Mount Nansen Electrical Assessment Final Report

Prepared for:
Kirsten Hulstein, Project Manager
Assessment and Abandoned
Mines
Government of Yukon

June 3, 2014

1 FEEDER AND TRANSFER SWITCH REVISIONS
 E01 SCALE: NTS

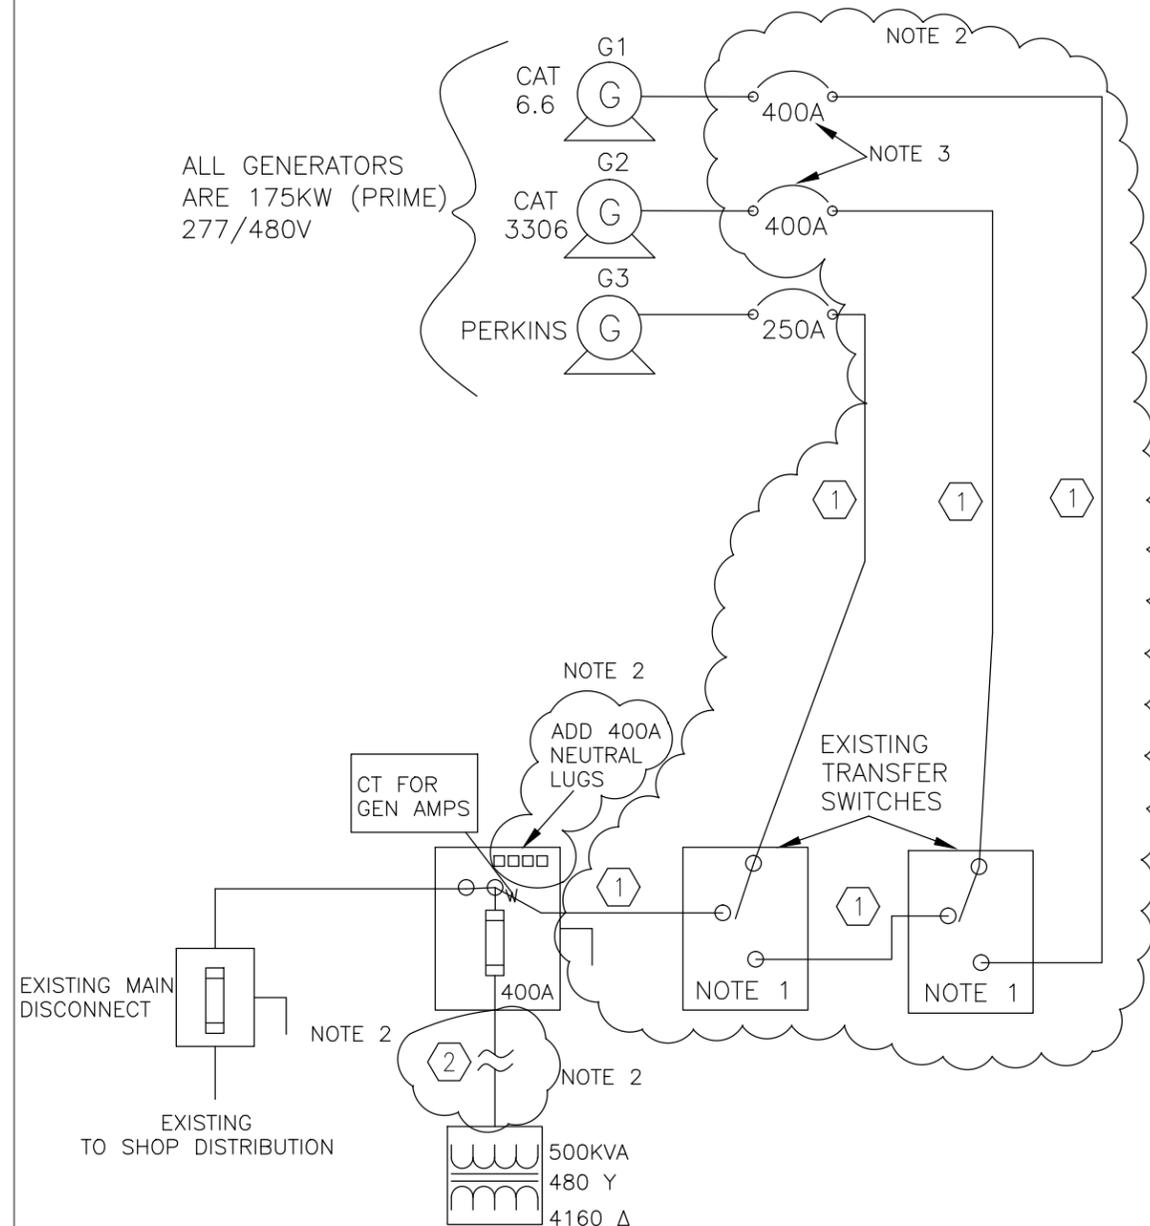
FR-E01.4	WT-01: Generator Grounding and Shop SLD: (Detail 2, E01) Contractor has abandoned old cables and conductors in place. DES electrician to remove cables where practical, and cut and mark cables to be left in place. Update 130830: Complete	Info
FR-E01.5	WT-01: Generator Grounding and Shop SLD: (Detail 2, E01) Grounding plates installed behind generator sea containers (x4), and connected with #1/0 AWG copper cable. Provide photos of installation, connectors, cable and burial depth.	Contractor
FR-E01.6	WT-02: Generator Feeders and Automatic Transfer Switches Main camp feeders are run overground from generator 3 sea container to site step-up 500kVA transformer. DES/AN have provided mechanical protection and high visibility marking of cables and protection. (photo removed) <i>Figure FRE-01.1: Temporary Cabling to Main Step-up Transformer</i> Cables to be sleeved with rigid metal pipe or drill steel, where subject to vehicle traffic. AAM/DES to conduct routine inspection of above ground cables, and maintain mechanical protection where necessary. Notify camp staff about locations of temporary cabling and safety procedures. Contractor to bury cables when ground conditions permit. Provide photos of trenching and cable installation. Update 130830: Cables buried. Provide photographs of burial. Update 130924: Burial information received indicating depths of burial and distance measurements at several intervals. Installation acceptable.	Info

FR-E01.4	WT-01: Generator Grounding and Shop SLD: (Detail 2, E01) Contractor has abandoned old cables and conductors in place. DES electrician to remove cables where practical, and cut and mark cables to be left in place. Update 130830: Complete	Info
FR-E01.5	WT-01: Generator Grounding and Shop SLD: (Detail 2, E01) Grounding plates installed behind generator sea containers (x4), and connected with #1/0 AWG copper cable. Provide photos of installation, connectors, cable and burial depth. UPDATE 140307: Photos reviewed, installation acceptable.	Info

MATERIALS LIST FOR E01-01

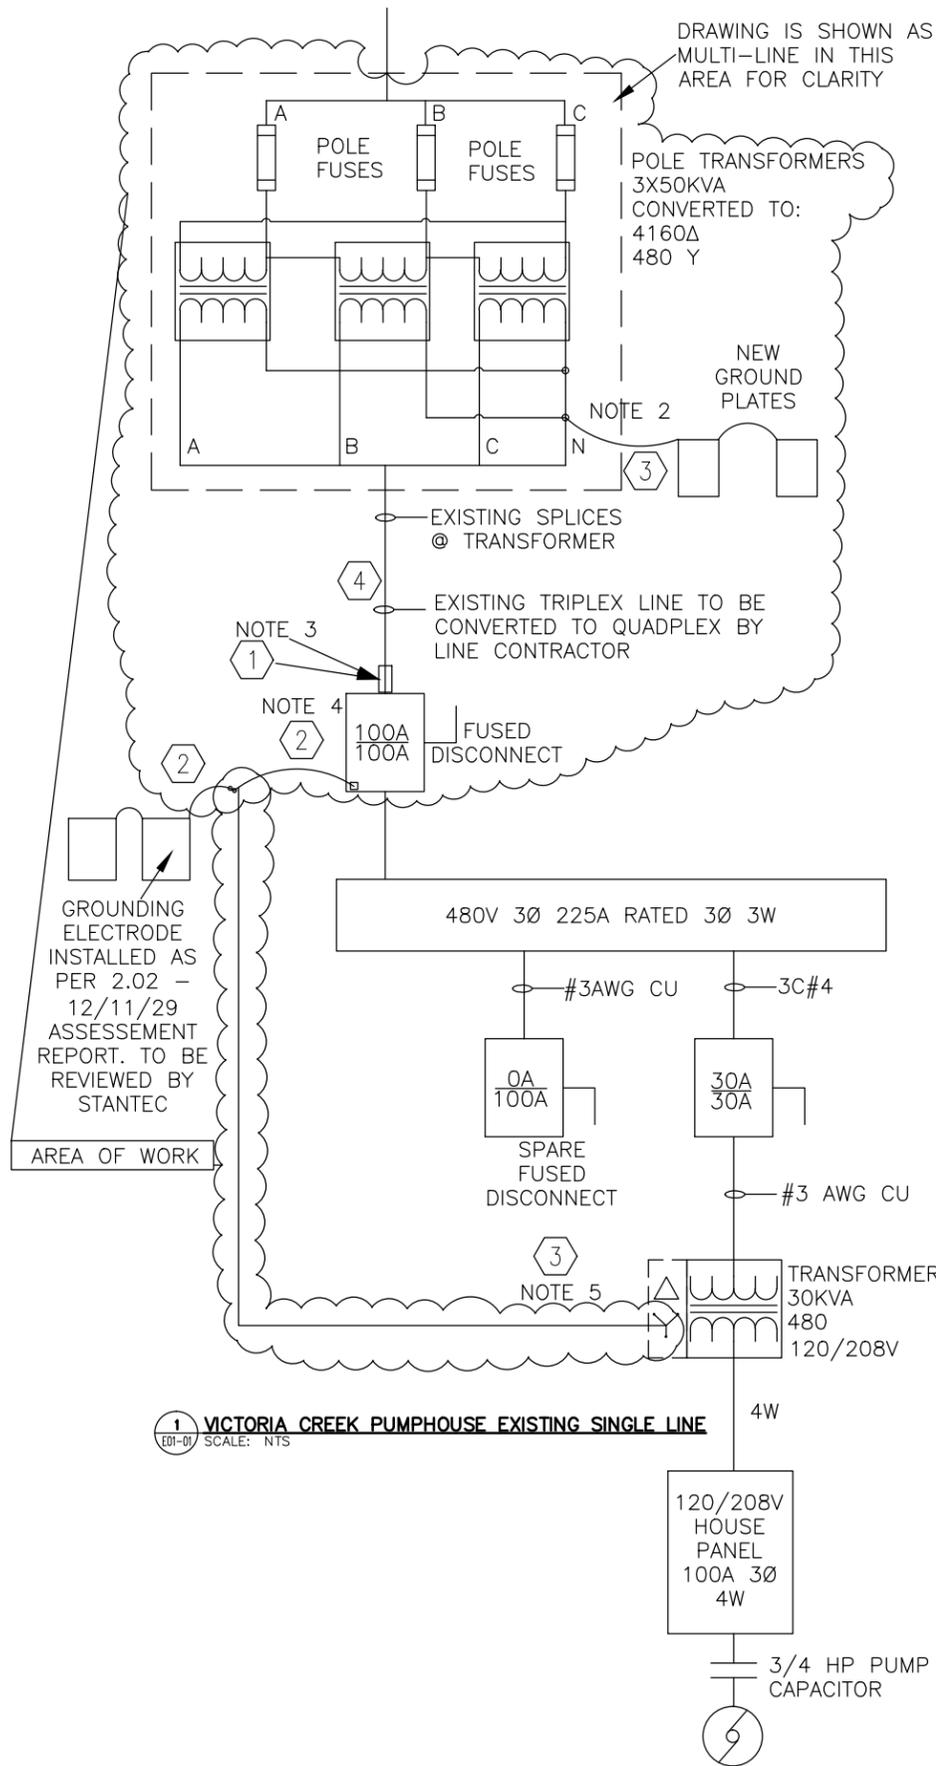
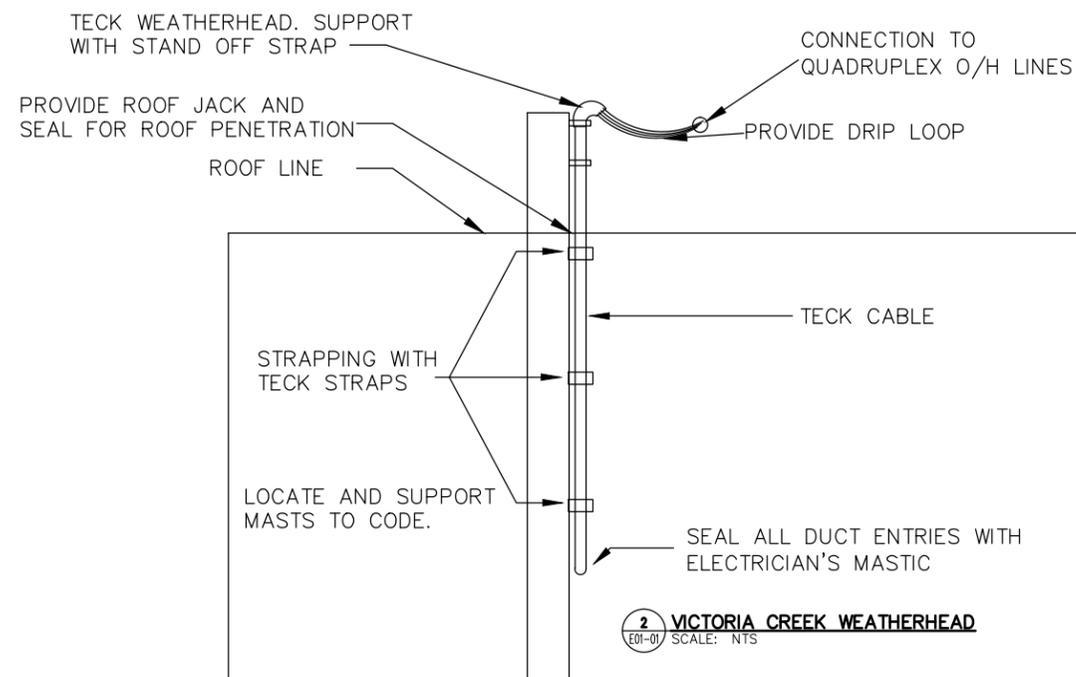
FR-E01.19	<p>WT-05: Victoria Creek Pumphouse Revisions (E01-01)</p> <p>DES has installed 1 grounding plate, instead of 2 shown on drawings. Change is acceptable. Note that grounding system was modified to include tie to overhead transformer case ground.</p> <p>Provide photos of ground plate installation: connectors, cables, burial depth and marking.</p>	Info
FR-E01.20	<p>WT-05: Victoria Creek Pumphouse Revisions (E01-01)</p> <p>AN provided 2 new ground plates for grounding of o/h transformers. Grounding plates were tied to existing ground rods. Installation acceptable.</p> <p>Provide photos of ground plate installation: connectors, cables, burial depth and marking.</p>	Contractor
FR-E01.21	<p>WT-05: Generator Shack Revisions (1/E01-02)</p> <p>New 3Ø combination load center in G3:Perkins sea container was not load balanced as per drawings and specifications. Measured loads on site were A(42A), B(68A), and C(59). Contractor to balance loads on A, C phases as per notes. Confirm loads are balanced within 20%.</p>	Contractor

FR-E01.18	<p>WT-05: Victoria Creek Pumphouse Revisions (E01-01) Service switch lamicoid label not installed. Contractor to install. 130830 Complete</p> <p>Ground fault monitoring panel not installed. Contractor to install. 130830 No Change- contractor to correct.</p> <p>Contractor to disconnect bare aluminum bond from service entrance switch bond lug. Cut bare aluminum bond at entrance to switch. Attach service grounding conductor to service entrance switch neutral lug and install grounding screw, to bond neutral block to switch case. 130830 Complete</p> <p>Change time delay fuses to HRC fuses as specified, or conventional fuses. TD fuses are not acceptable. 130830: Fuses changed to Class K5. Fuses acceptable. Provide spares.</p> <p>Strapping of teck cables was incomplete at time of review. Contractor to correct. 130830 No change- contractor to correct.</p> <p>Provide photos of completed installation.</p>	Contractor

FR-E01.18	<p>WT-05: Victoria Creek Pumphouse Revisions (E01-01)</p> <p>Service switch lamicoid label not installed. Contractor to install.</p> <p>130830 Complete</p> <p>Ground fault monitoring panel not installed. Contractor to install.</p> <p>130830 No Change- contractor to correct.</p> <p>UPDATE 140307: Complete</p> <p>Contractor to disconnect bare aluminum bond from service entrance switch bond lug. Cut bare aluminum bond at entrance to switch. Attach service grounding conductor to service entrance switch neutral lug and install grounding screw, to bond neutral block to switch case.</p> <p>130830 Complete</p> <p>Change time delay fuses to HRC fuses as specified, or conventional fuses. TD fuses are not acceptable.</p> <p>130830: Fuses changed to Class K5. Fuses acceptable. Provide spares.</p> <p>UPDATE 140307: Complete</p> <p>Strapping of teck cables was incomplete at time of review. Contractor to correct.</p> <p>130830 No change- contractor to correct.</p> <p>UPDATE 140307: Complete</p> <p>Provide photos of completed installation.</p> <p>UPDATE 140307: Photos reviewed by Corry Martin</p>	Info

FR-E01.19	<p>WT-05: Victoria Creek Pumphouse Revisions (E01-01)</p> <p>DES has installed 1 grounding plate, instead of 2 shown on drawings. Change is acceptable. Note that grounding system was modified to include tie to overhead transformer case ground.</p> <p>Provide photos of ground plate installation: connectors, cables, burial depth and marking.</p> <p>UPDATE 140307: Photos reviewed by Corry Martin</p>	Info
FR-E01.20	<p>WT-05: Victoria Creek Pumphouse Revisions (E01-01)</p> <p>AN provided 2 new ground plates for grounding of o/h transformers. Grounding plates were tied to existing ground rods. Installation acceptable.</p> <p>Provide photos of ground plate installation: connectors, cables, burial depth and marking.</p> <p>UPDATE 140307: Photos not available. Contractor certifies installation is correct. Installation acceptable.</p>	Info
FR-E01.21	<p>WT-05: Generator Shack Revisions (1/E01-02)</p> <p>New 3Ø combination load center in G3:Perkins sea container was not load balanced as per drawings and specifications. Measured loads on site were A(42A), B(68A), and C(59). Contractor to balance loads on A, C phases as per notes. Confirm loads are balanced within 20%.</p> <p>130830: Not complete. Update panel directory to suit.</p> <p>UPDATE 140307: Complete</p>	Info
